Technical information

TI No.: 15.40U08377A

MODEL: CC 500; TC 400; TRAVEGO Euro VI; INTEGRO; MC400
 MODEL SERIES: 410200; 410210; 410230; 410240; 410250; 410260; 410270; 410280;
 410320; 629540; 629557; 632400; 632430; 632450; 633330; 633660
 TITLE: **Alternator - line routing to earth connection (alternator 3)**

Rerouting the line to the earth connection at alternator 3

M15.40-0026-81

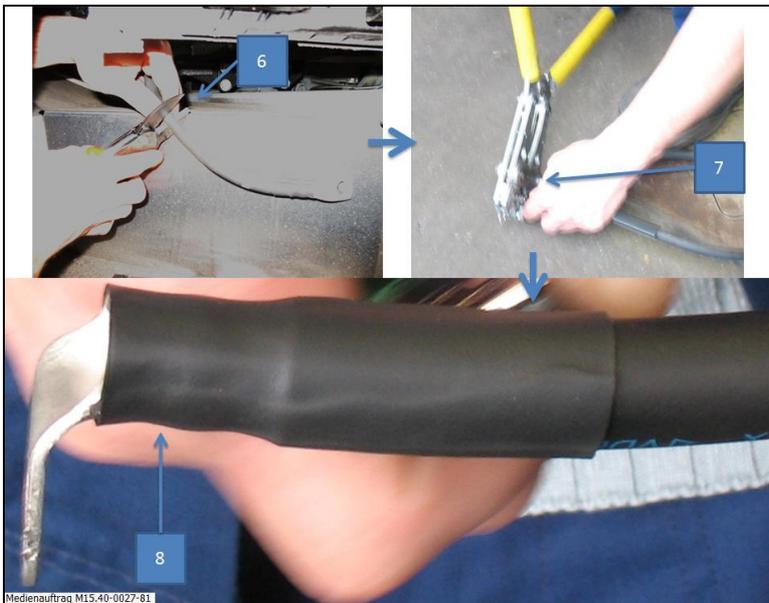
- Possible chafe point (3) at B+ connection of alternator.
- Remove the earth cable from fastening points (4) and (5).

M15.40-0027-81

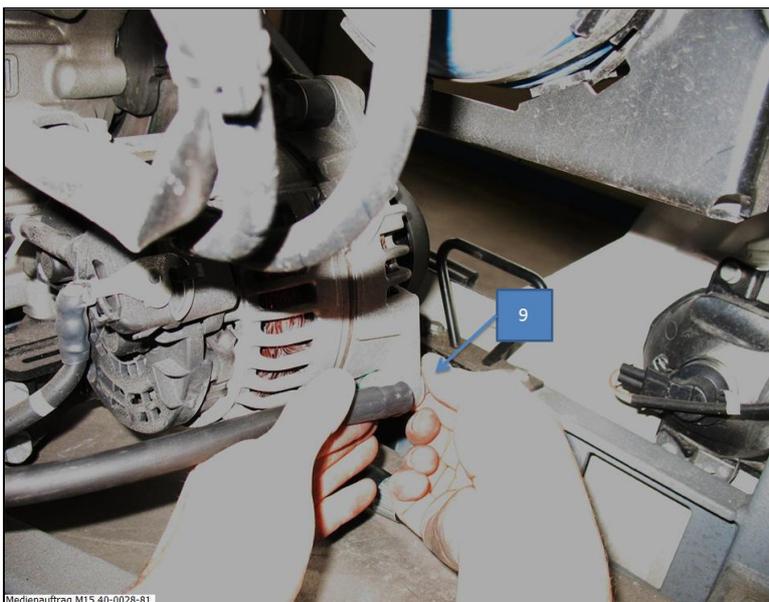
- Sever the earth cable at approximately 18 cm (6).

Before the earth cable is severed, check the tolerances in the wiring harnesses and adapt cable length if necessary.

- Fit cable lug (7).
- Ready prepared angled cable lug (8) with heat-shrink tubing.
